To: Ken Roberts, City of Lake Elmo Planning Director
From: Lucius Jonett, Wenck Landscape Architect
Date: July 22, 2019
Subject: City of Lake Elmo Landscape Plan Review
Kwik Trip Store #1078, Review #1

CONVENIENCE STORE #1078
WITH SINGLE BAY CARWASH

LANDSCAPE PLAN

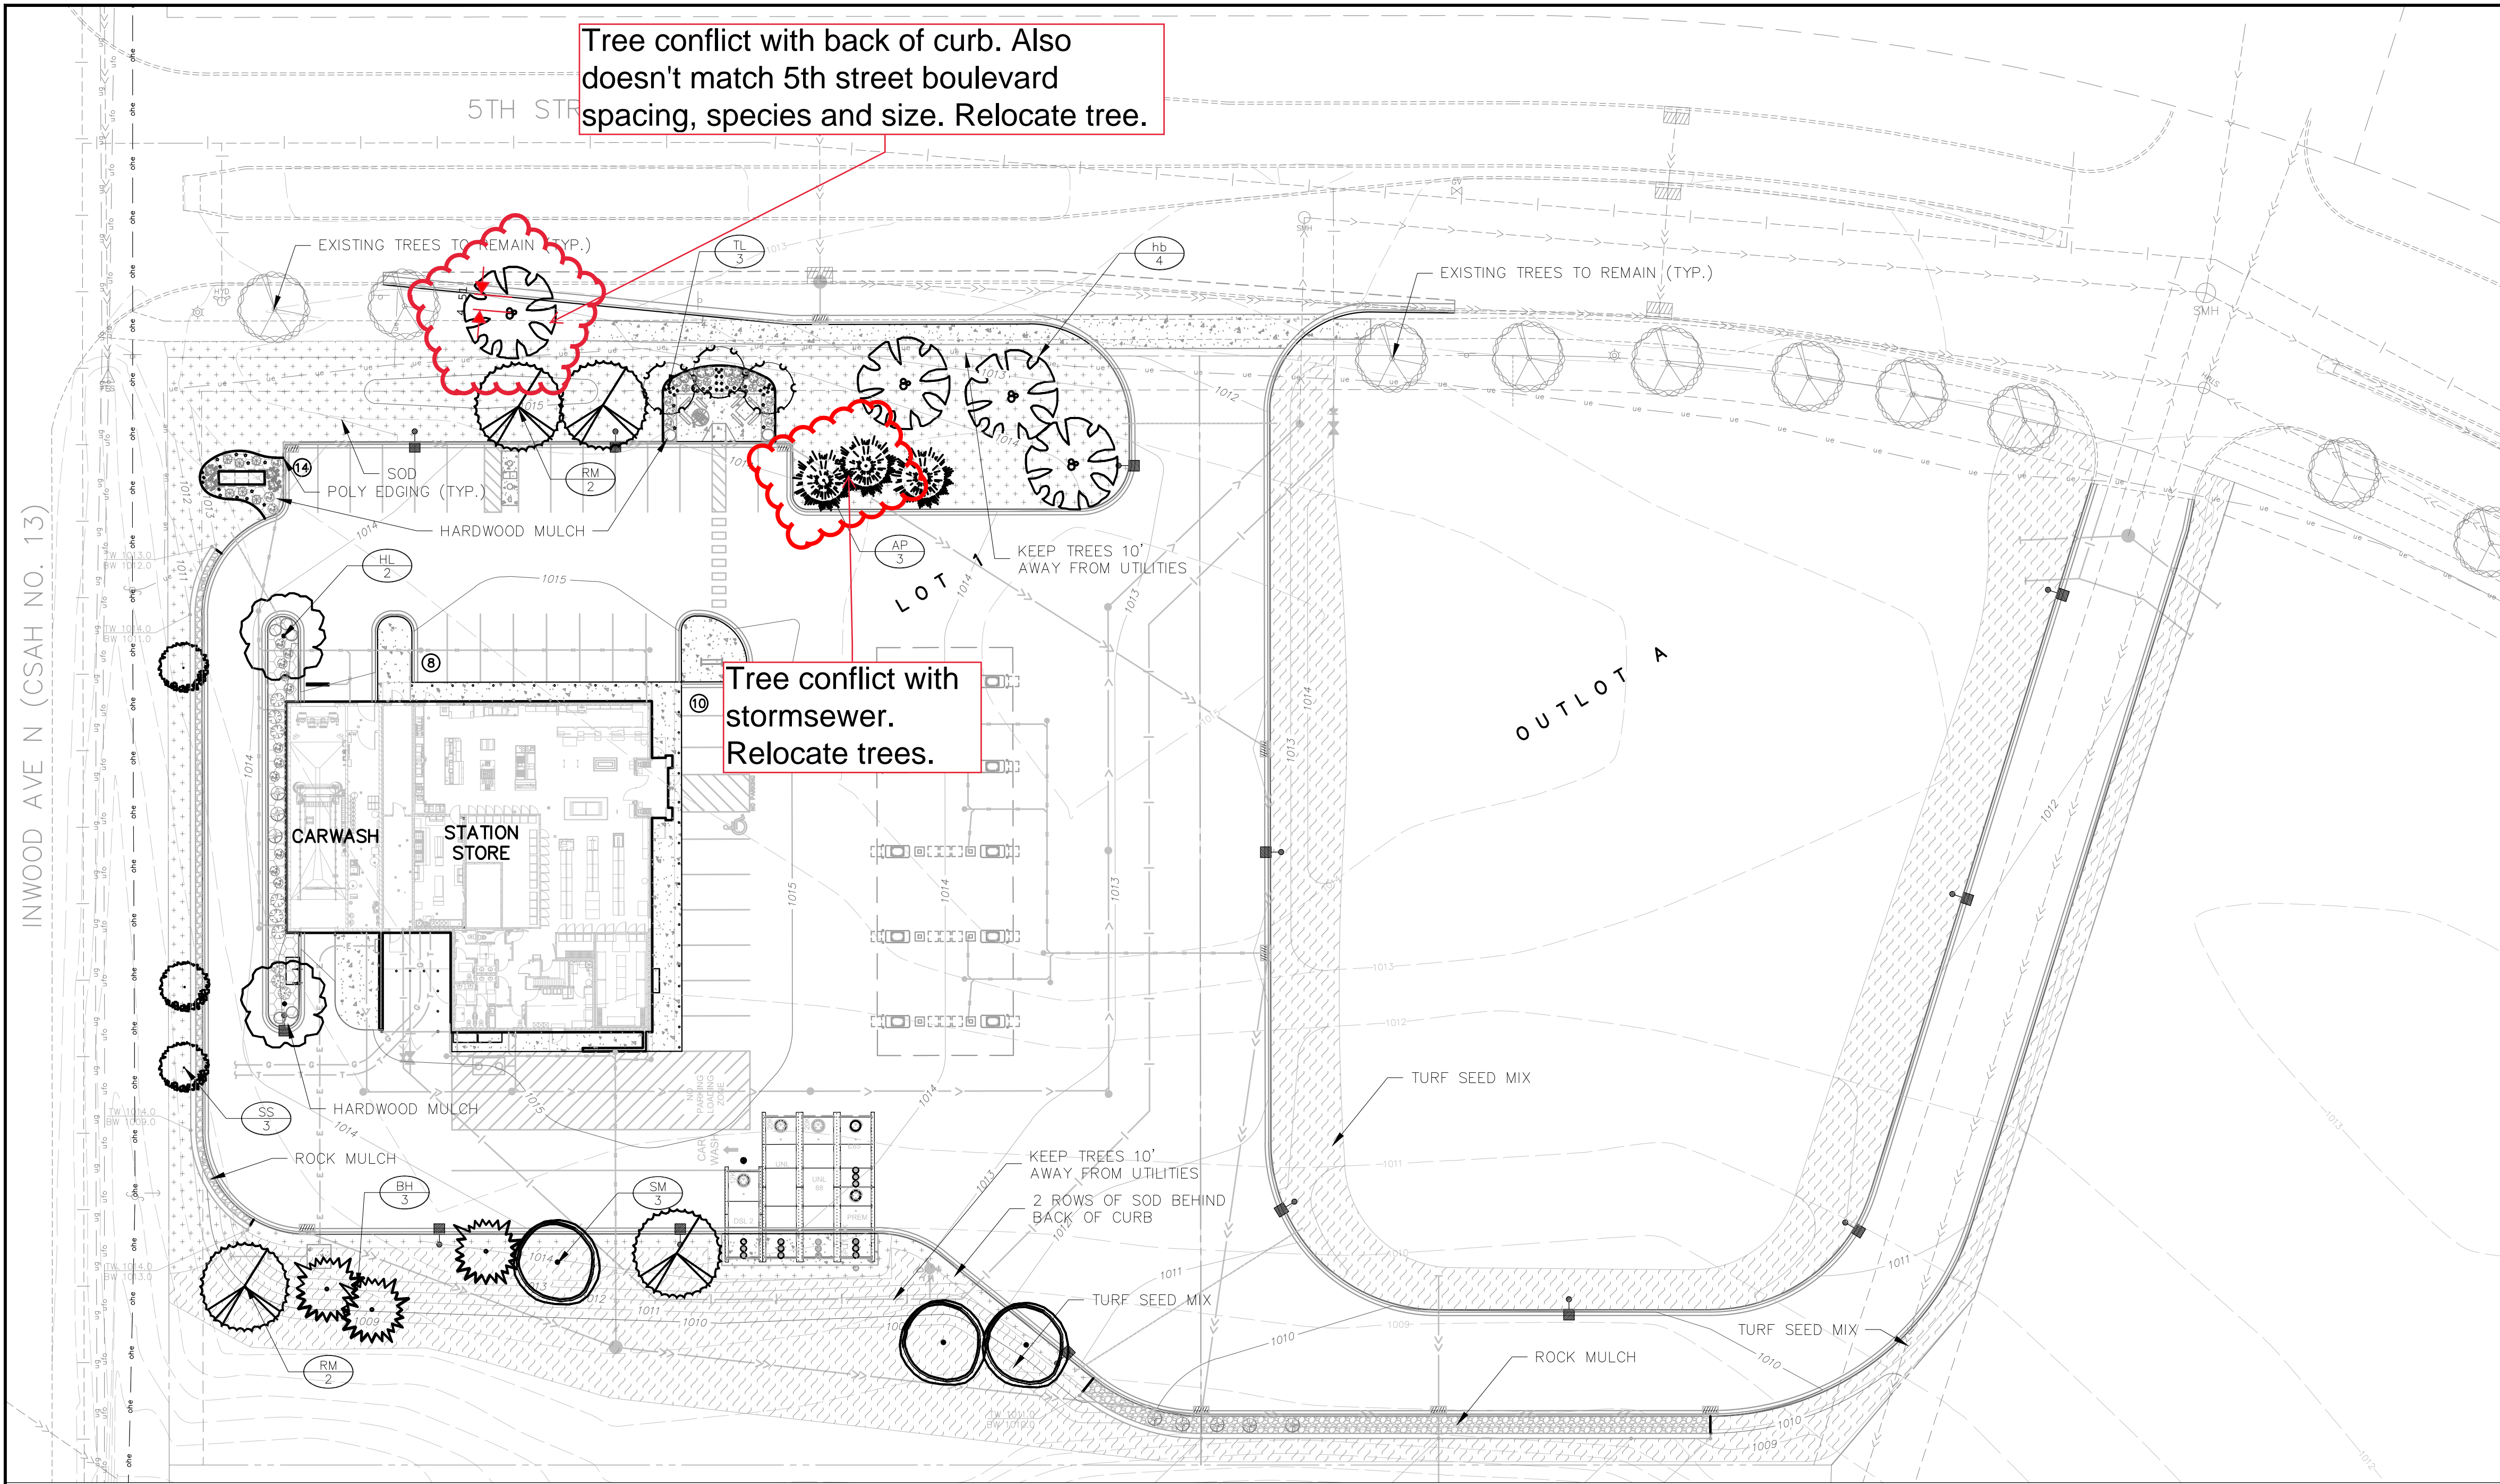
1. The submitted landscape plan does not meet the required number of trees. 3 Additional trees are needed to account for the Perimeter Parking Lot Frontage.
2. The proposed development has perimeter parking along 5th Street that requires perimeter parking lot landscaping.
3. One tree was found to be in conflict with sidewalk and curb setbacks and should be relocated to elsewhere on the property. See attached markup plan.
4. Two evergreen trees are in conflict with proposed stormsewer and should be relocated to elsewhere on the property. See attached markup plan.
5. 6" of topsoil is required versus the 4" of topsoil stated in the notes. See attached markup plan.

1. Submit a revised landscape plan to address the findings above.
